## **New Woodford County High School: Change Order #014 Summary**

DATE:	12/16/2024	PR #:	PR 079
TO:	Clay Ratliff – Trace Creek Construction Mike Grayson – Trace Creek Construction	RE:	Woodford County Board of Education Versailles, Kentucky BG 19-353 RTA 1916

**Woodford County High School Phase 1**

SD1.5 – SITE DEVELOPMENT AND LAYOUT PLAN  
SD1.6 – SITE DEVELOPMENT AND LAYOUT PLAN

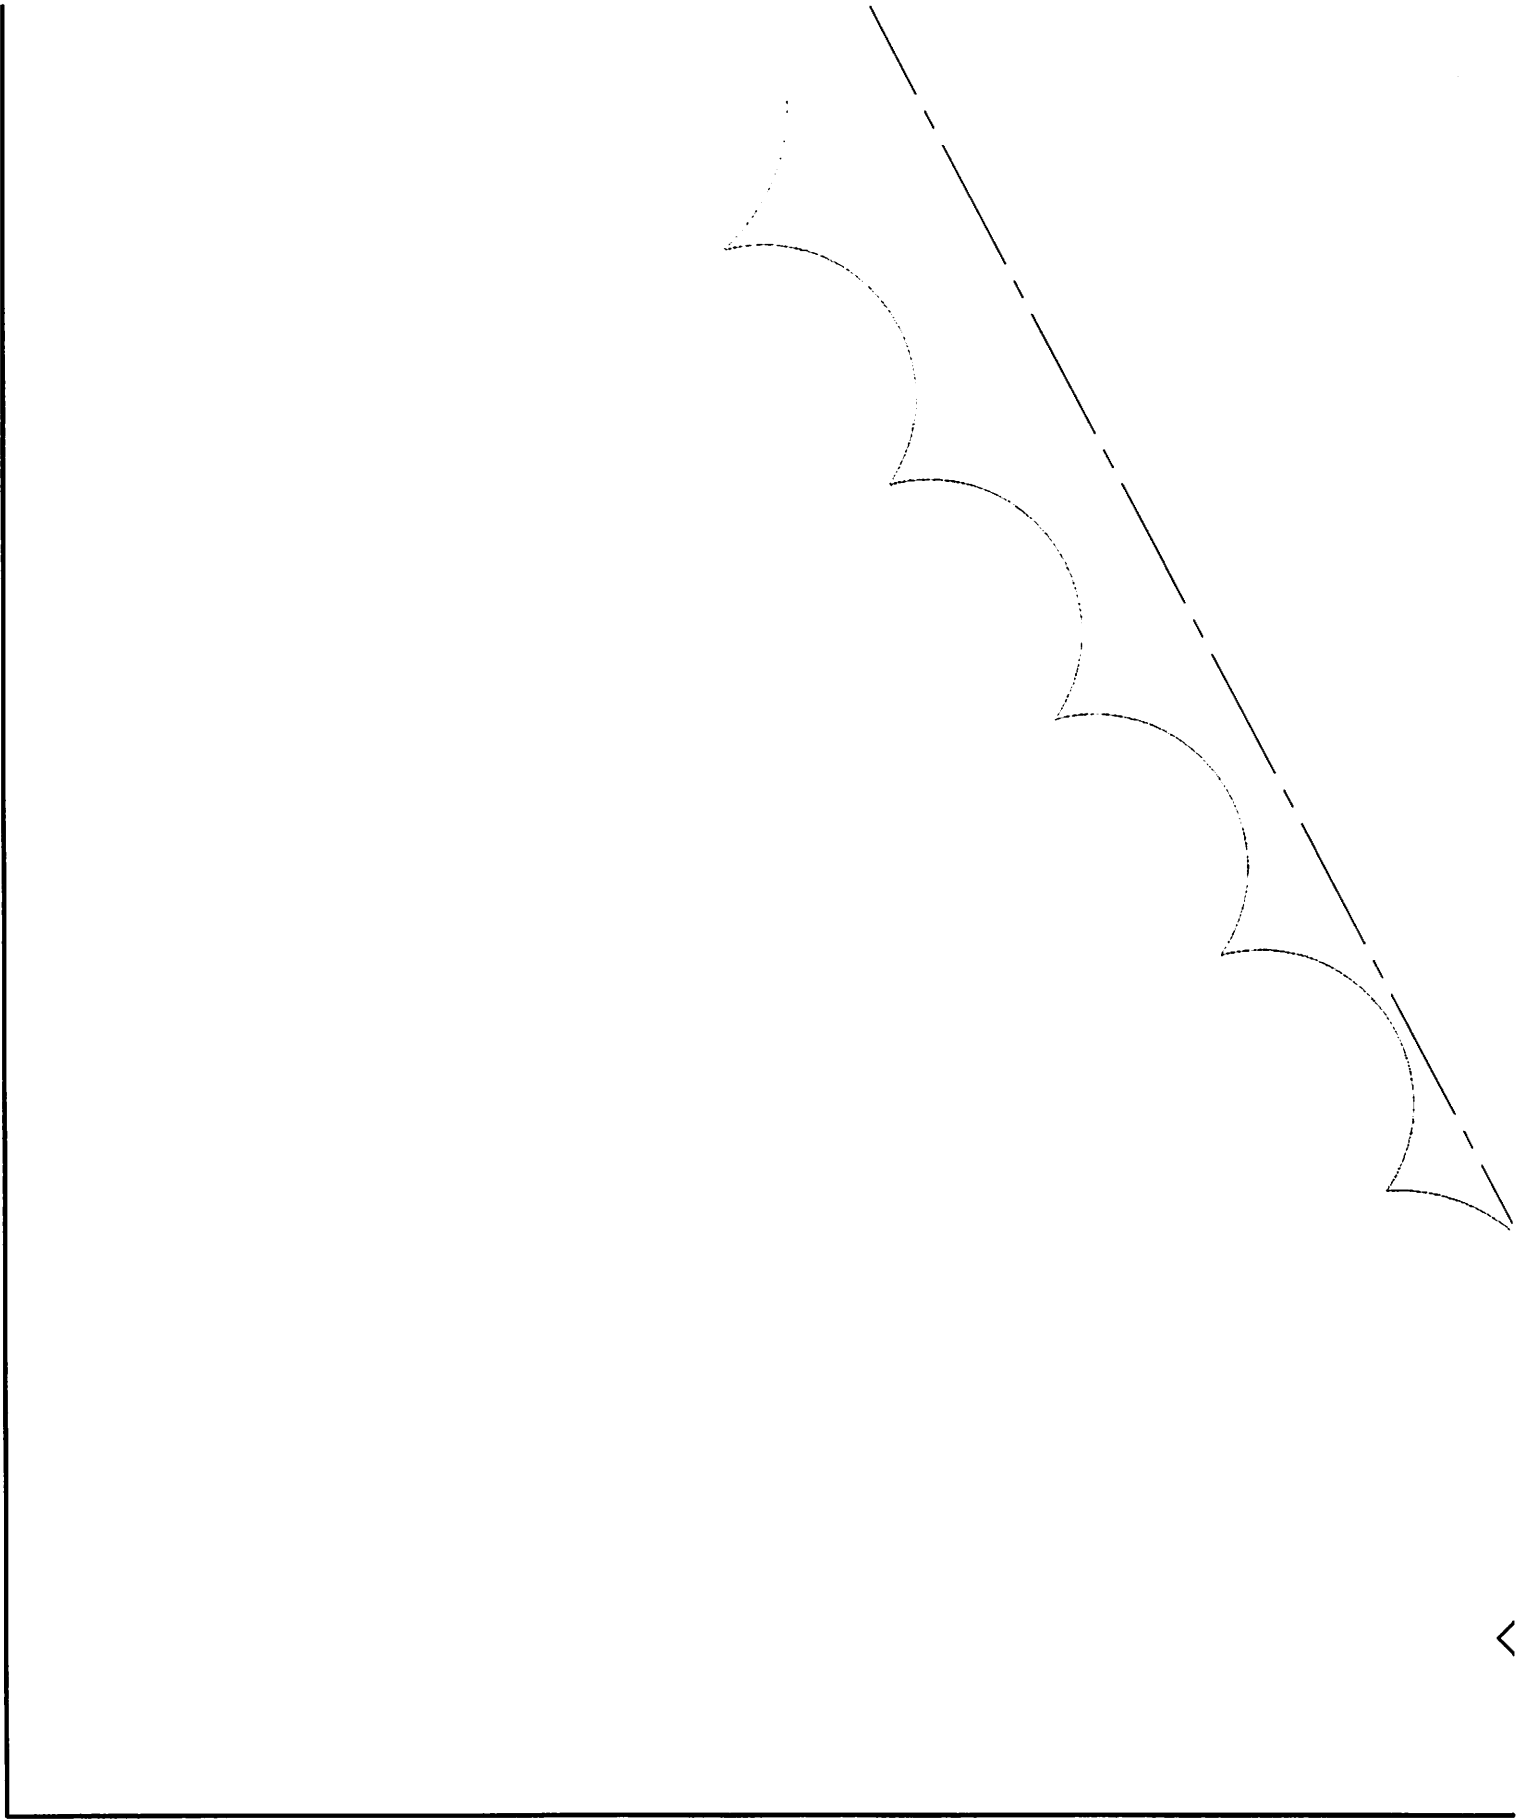
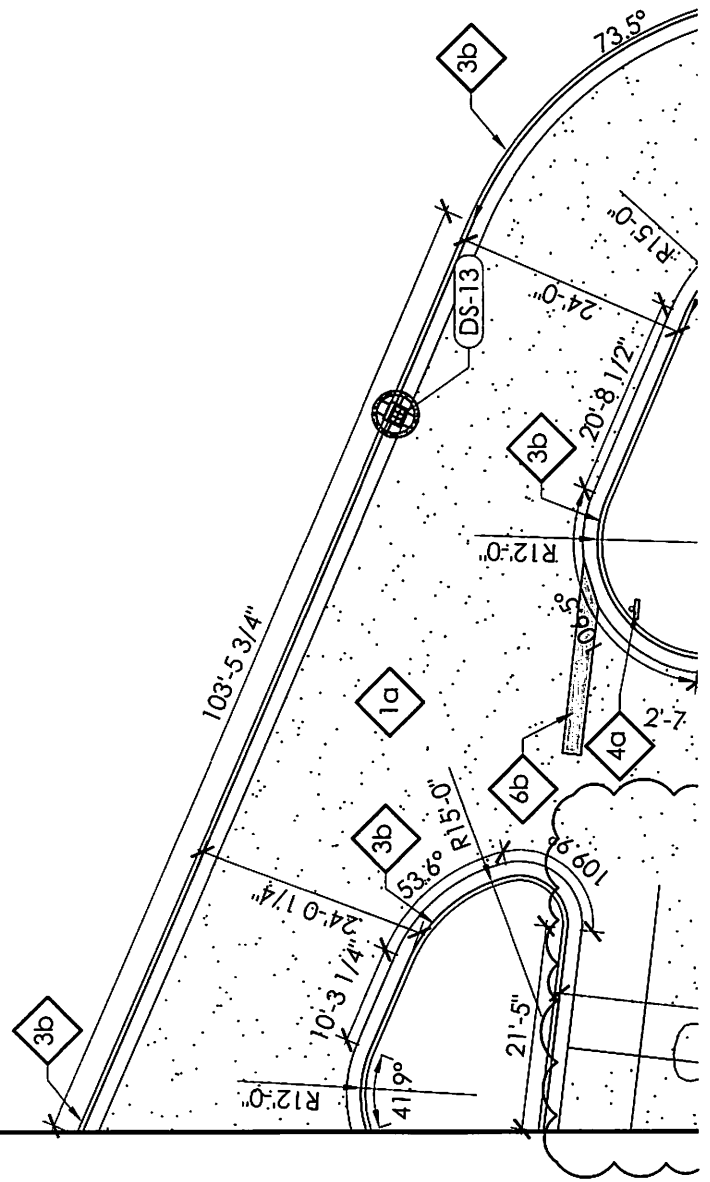
1. Refer to SD1.5 – SITE DEVELOPMENT AND LAYOUT PLAN and SD1.6 – SITE DEVELOPMENT AND LAYOUT PLAN
  - a) Striping is to be yellow 2" and include yard lines and hash marks. Parking lot striping is to take precedence, and the band striping shall appear under the parking lot striping.
  - b) Numbers are to be outlined with 2" yellow paint and are not to be filled.
  - c) Striping for the field shall extend as shown on attachments as well.

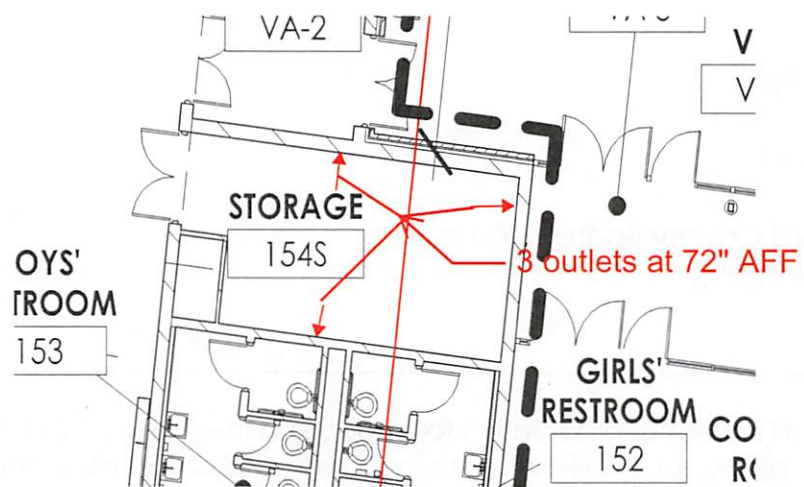
1. "Provide duplex outlet below stair ST-D on plan east wall (coordinate rough-in location with Trace Creek). Route 2#12, #12 ground in wire mold where exposed, and paint to match wall surface. Transition to EMT where above ceiling. Connect to the nearest convenience receptacle circuit and as-built. Suggested options for circuit: 1RP2-15, 1ENG1-14, 1ENG1-38. If none of these are accessible, a new circuit from spare 20A/1P breaker in panel 1ENG1 is acceptable."

2. Refer to room Storage 154S. Provide (3) duplex receptacles in this room and locate per Trace Creek direction (SEE ATTACHED). Each circuit to be dedicated, 2#12, #12 ground to the following 20A/1P spare circuit breakers: 2RP8-41,43,45. Where exposed in storage room, route circuit in wire mold and paint to match walls.

3. Refer to E6.0 enlarged kitchen plan. Revise circuits for kitchen equipment causing GFCI nuisance trips to be hardwired in lieu of plug and cord. Bypass Northshore GFCI device for all revised circuits. Field coordinate with Trace Creek.

PR83.1

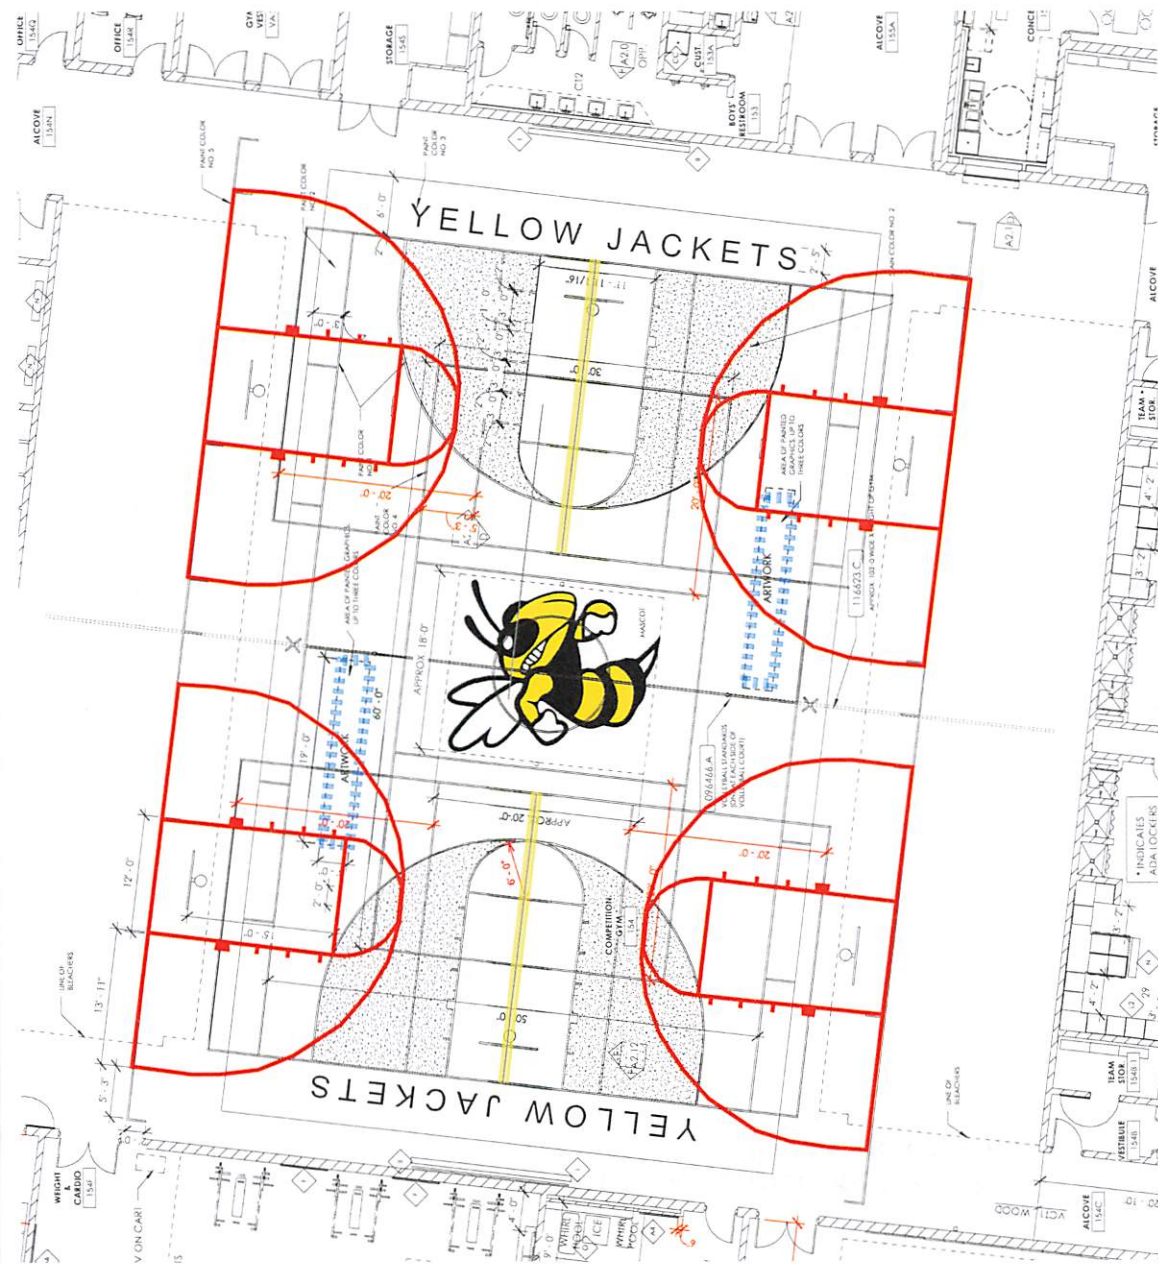
1. Refer to attached **PDF**:
  - a) Provide center stripe at cross-court volleyball courts as shown in yellow highlight on the attached PDF. Court line shall be painted in tan.
  - b) Provide fully striped side basketball courts as shown in red on attached PDF. These will also be painted in tan.
  - c) All new striping shall be applied to go under existing main court striping. New lines shall not supercede existing main court.
